Revised 10 March 2023

Job No. 22135

Subject: Geologic feasibility of proposed development  
Proposed housing  
900 High Street  
Santa Cruz, CA 95060  
County of Santa Cruz APN 001-022-40

**Plate 1**

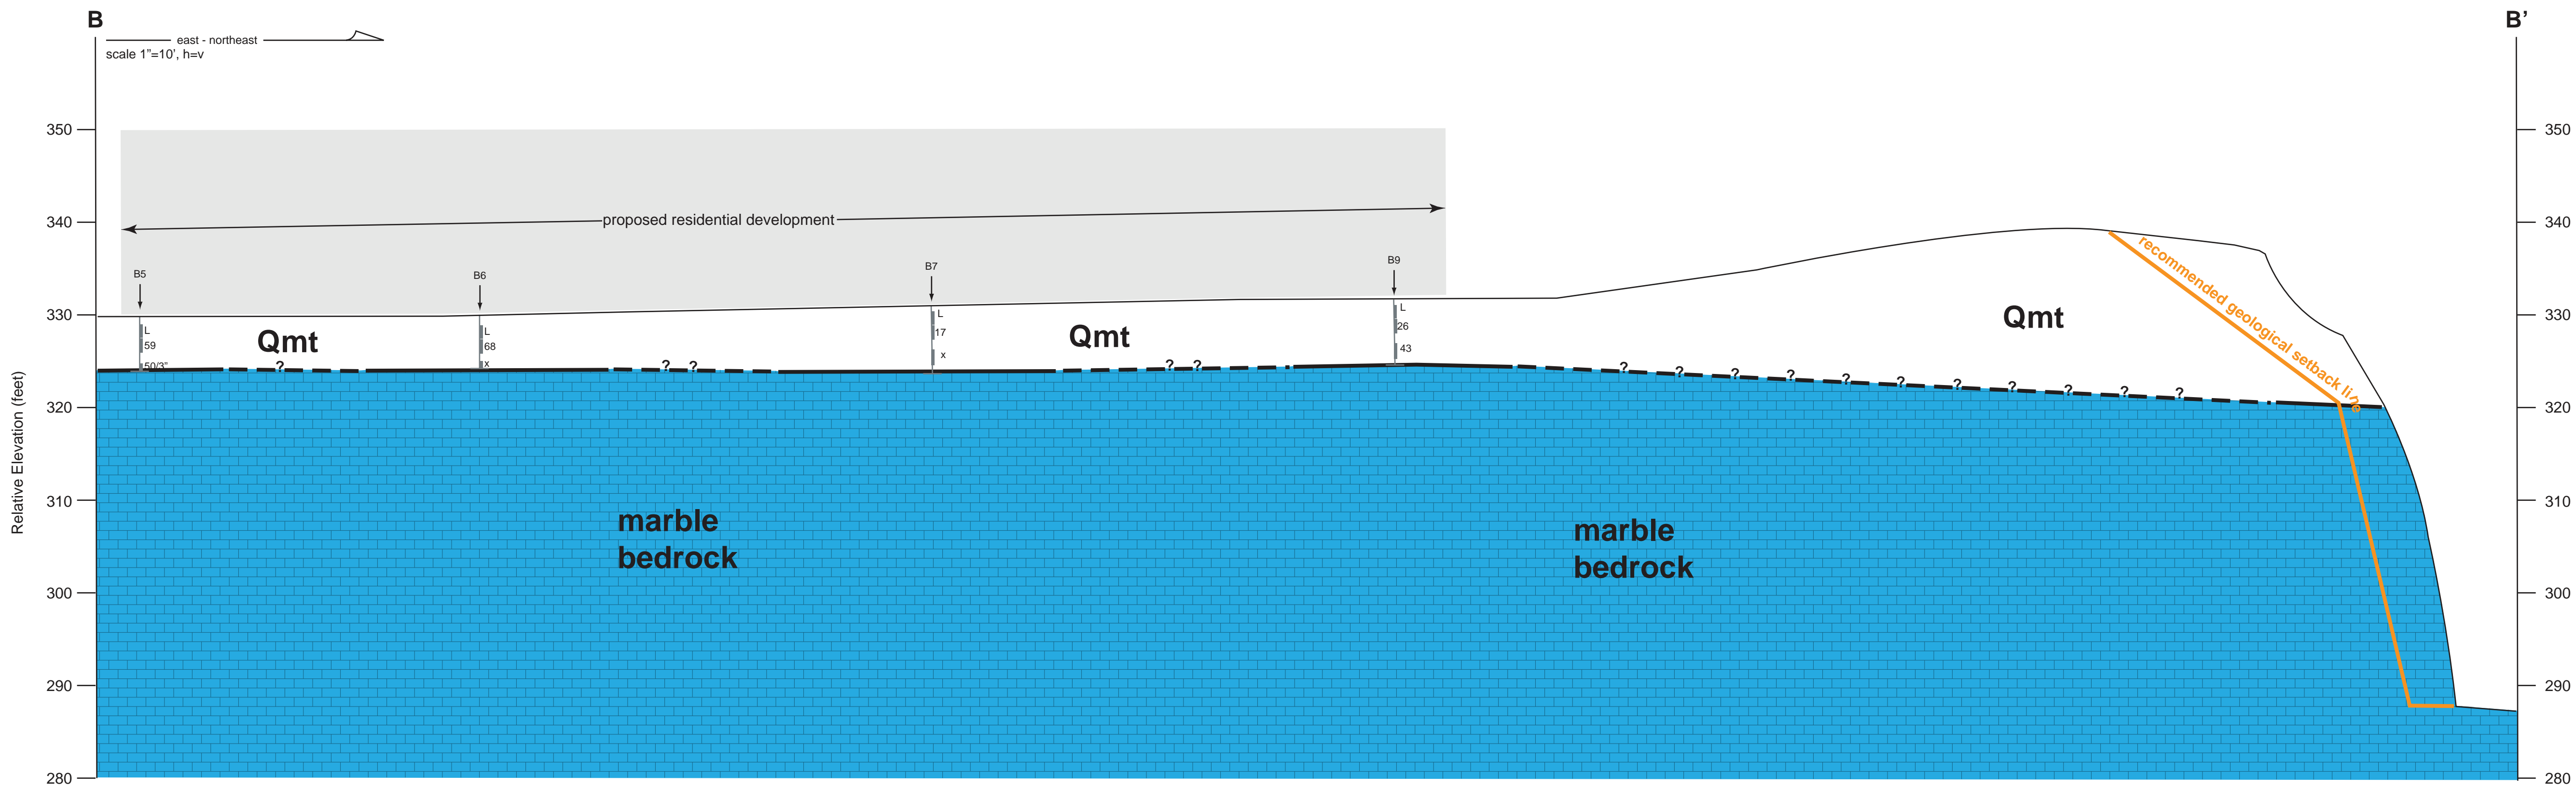
- 1. The project geotechnical engineer should analyze the blanket of denser soils that overlie the marble bedrock in the area centered on boring B2, flagged as a doline of concern (shaded orange polygons on Plate 1), taking our prescribed maximum doline width into account. The geotechnical engineer should determine if the density and thickness of this surficial "blanket" is sufficient to buffer any structures from damage caused by the potential stoping or settlement of the relatively softer soils below.*

4. The project geotechnical engineer should analyze the blanket of denser soils that overlie the marble bedrock in the area centered on boring B2, flagged as a doline of concern (shaded orange polygons on Plate 1), taking our prescribed maximum doline width into account. The geotechnical engineer should determine if the density and thickness of this surficial "blanket" is sufficient to buffer any structures from damage caused by the potential stoping or settlement of the relatively softer soils below. Mitigation of this condition should be proposed if warranted. Mitigation schemes could potentially include proper foundation design, ground improvement under the foundation, or subsurface changes made to the soft soil zones.
